Response to Submissions

Mt Bundarbo Quarry

October 2021

Project Number: 20-481

Figure 2-1 Essential Energy HV and TR network in proximity to the proposal

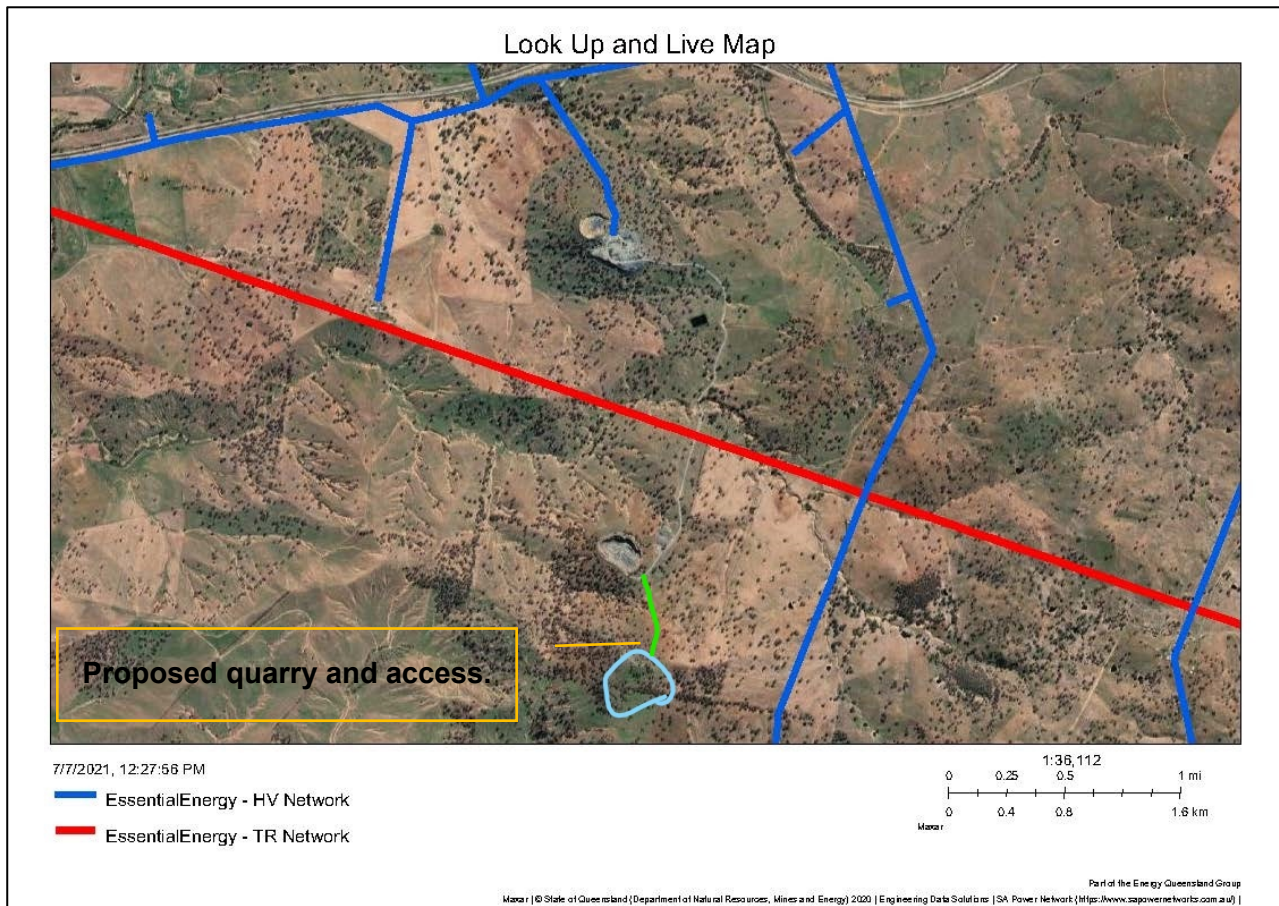
Issue	Response
<p>Essential Energy notes that existing overhead powerlines are impacted by the proposed development, and it has safety concerns in relation to the proximity of the proposed development to its powerlines.</p> <p>Please have the Applicant provide a full site plan showing:</p> <ul style="list-style-type: none">• The location of the existing overhead powerlines and poles.• The location of the proposed quarry works and the distance (horizontal) to the overhead powerlines and poles.	<p>The location of the Essential Energy high voltage (HV) and low voltage (TR) network are provided in Section 2.3 and Figure 2-1.</p> <p>The proposal does not impact the current network.</p>

The proposal does not impact the existing HV and TR network. The location of the Essential Energy HV and TR network are provided in Figure 2-1.
